1. **“Royal Holladay Hills, Block G”, Preliminary Subdivision Plan – 4885 South Rodeo Walk R-M/U Zone**  
Preliminary review and consideration of residential development details proposal by Applicant, Steve Peterson. The Commission will review development specific details of this Conceptually approved site within the Royal Holladay Hills Mixed use development. All considerations of this as a permitted use shall be according to regulatory provisions of the Site Development Master Plan (SDMP 2007) and Holladay Ordinance §13.65.07(C)  
*File #19-9-19-8*
2. **Approval of Minutes - Sept. 3<sup>rd</sup>**

CITY OF HOLLADAY  
Planning Commission  
October 29<sup>th</sup> 2024  
Item #1

Request: **Preliminary Plan / Final plat - Block “G” within Royal Holladay Hills**  
Project: Development and construction review of 3.35 acres of residential development within the R/M-U Zone  
Address: 4885 South Rodeo Walk Drive  
Applicant: Steve Peterson, Holladay Hills, LLC  
File No: 19-9-19-08  
Planner: Jonathan Teerlink

Conceptual Site Plan

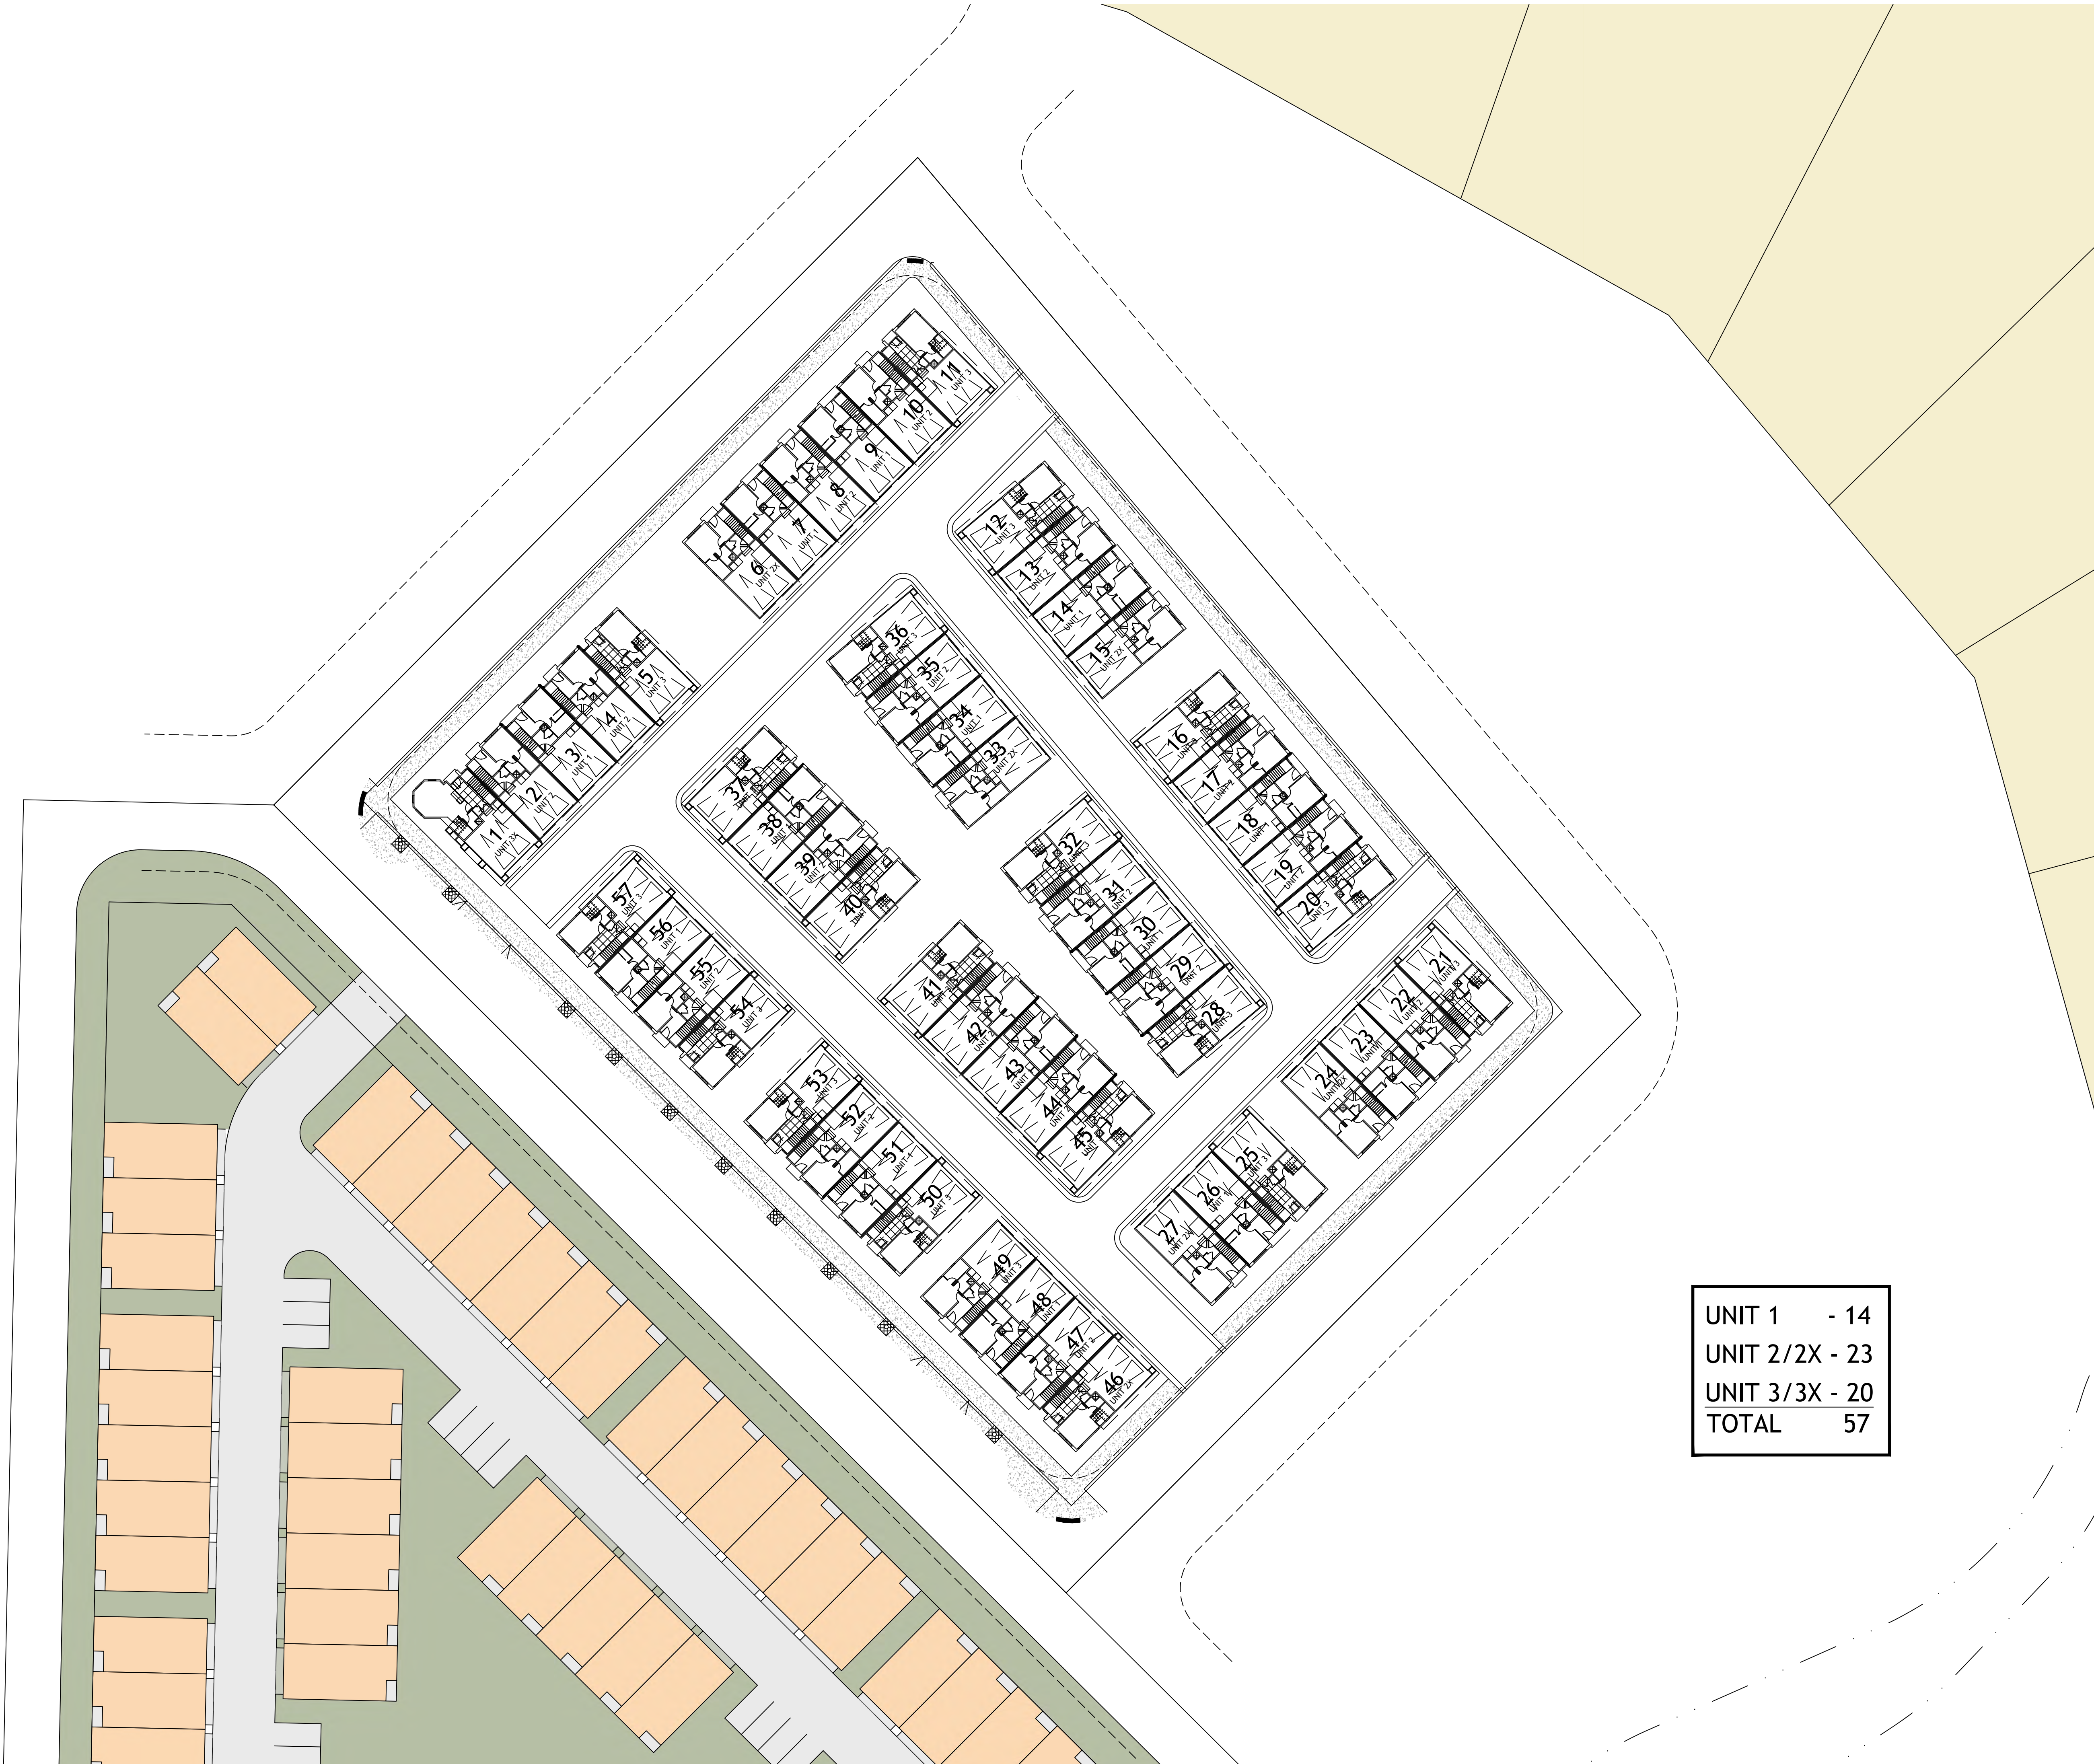
3  
4 Chair Roach pointed out that there is a Concept Site Plan with trees shown. He was not certain  
5 how all of those trees would actually fit on the backside of the homes, because it appears to be  
6 largely hardscape. Mr. Teerlink agreed that it looks like a tight area. That can be clarified as well.

1 Chair Roach noted that there were some questions raised during the Work Session about the  
2 architectural style. He referenced Page 13 of the Staff Report and noted that there appear to be  
3 trees in between the garages on the back side. He wanted to know if that is viable because it looks  
4 like a 2x3 space there. Mr. Peterson explained that this is still conceptual in nature. There will be  
5 a more detailed plan prepared for the next phase of the process. If trees are not viable there, then  
6 there will likely be some sort of bush planted. The actual details will be provided in the future.
